Access Compliance Report

Public Rights-of-Way

(Curb Ramps)

Intersection ID: 13118	Main Street: E_7TH_ST	Cross Street: CENTRAL_AV	Location: W
ADA ID: 5478BA359B4B	Ramp Type: PerpDiag	Initial Pass/Fail: Fail	Overall Compliance: No
Severity Score: 8.75			
Codes/Mitigation Info/Possible Solution		Field Measurements/Component Compliance

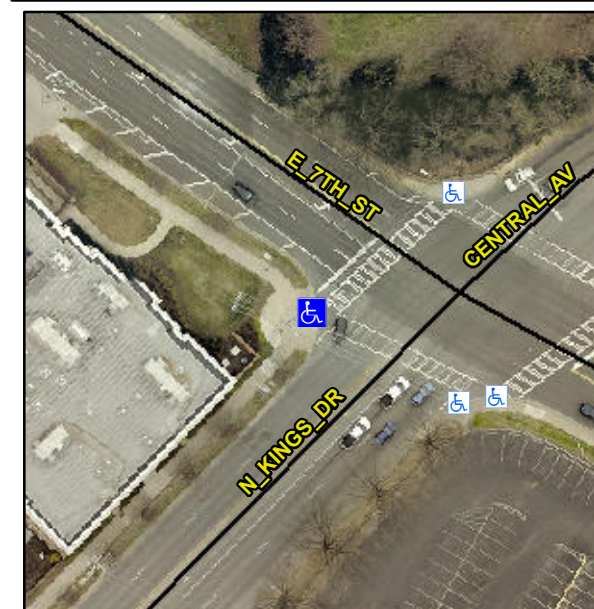
Remove & Replace Curb Ramp With Two New Directional Ramps or Equivalent.

Not Found, R304.5.1
